SUBJECT: AMENDMENT NO.183 TO FACILITY OPERATING LICENSE NO. DPR-49
(TAC NO. M82524)

DUANE ARNOLD ENERGY CENTER

Amendment No. 183
License No. DPR-49

SAFETY EVALUATION BY THE OFFICE OF NUCLEAR REACTOR REGULATION
RELATED TO AMENDMENT NO. 183 TO FACILITY OPERATING LICENSE NO. DPR-49

DAEC Iowa Electric Light and Power Company Technical Specifications
Thermal Power vs Core Flow Limits for Thermal Hydraulic Stability Surveillance Figure 3.3-1

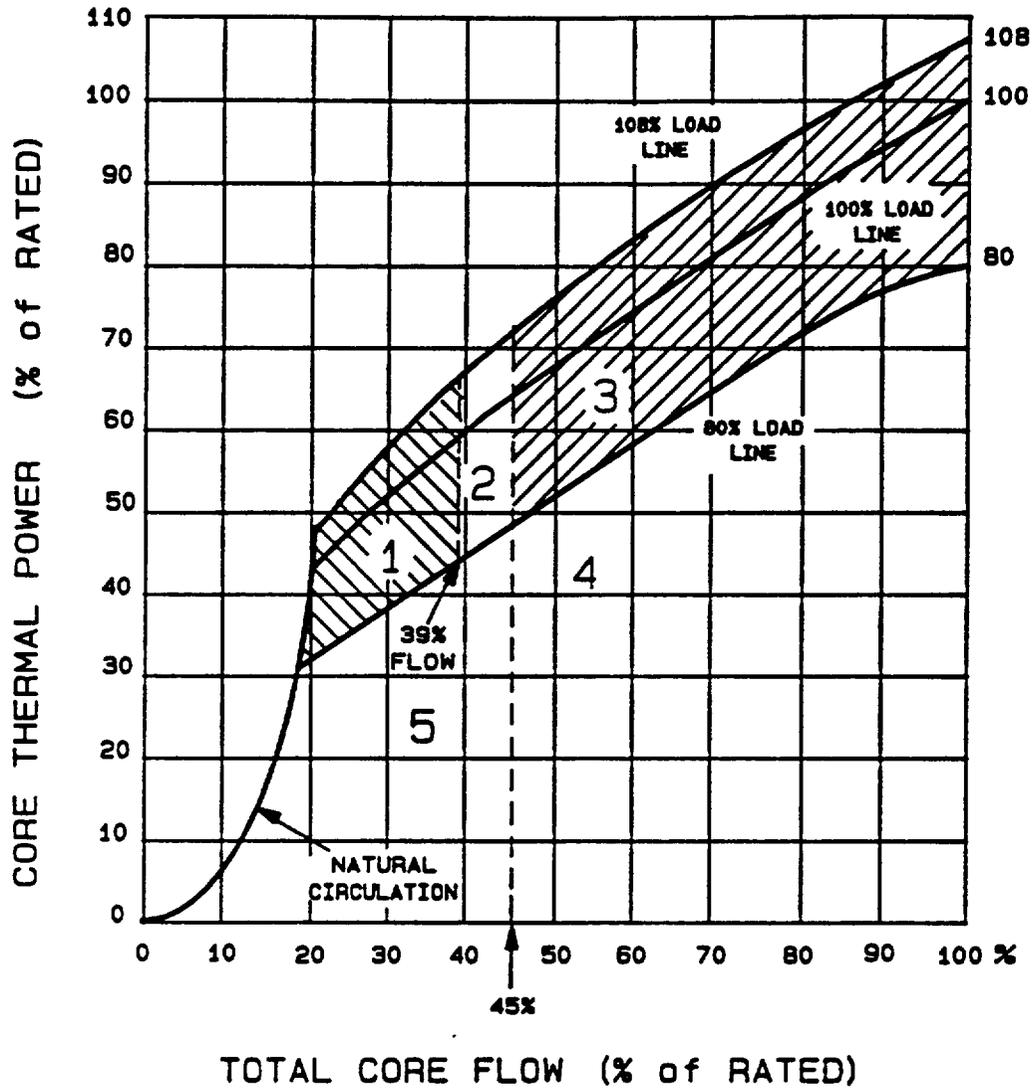
In addition, an LCO was added to address inadvertent entry into Region 1 of Figure 3.3-1 (greater than the 80% load line and less than 39% rated core flow.) The action statement is consistent with current operating practice in avoiding areas where the increased likelihood of thermal-hydraulic instability could exist. This action, however, was not specifically stated in the TS previously.

Figure 3.3-1, the graph of Thermal Power vs Core Flow Limits for Thermal Hydraulic Stability, was redrawn for clarity and incorporates the requirements of the figure and the text as they presently appear in the TS. The new figure will more closely resemble those used during plant operation, and more clearly define the various regions of concern for LCOs and SRs.

- Region 1: Two Loop Surv. Region, SLO Prohibited Region
- requires APRM/LPRM noise monitoring
- Region 2: Two Loop & SLO Surv. Region
- requires APRM/LPRM noise monitoring
- Region 3: SLO Surv. Region
- requires APRM/LPRM & Core Plate D/P noise monitoring
- Region 4: Extended SLO Surv. Region
- requires Core Plate D/P noise monitoring
- Region 5: Unrestricted Two Loop & SLO Region
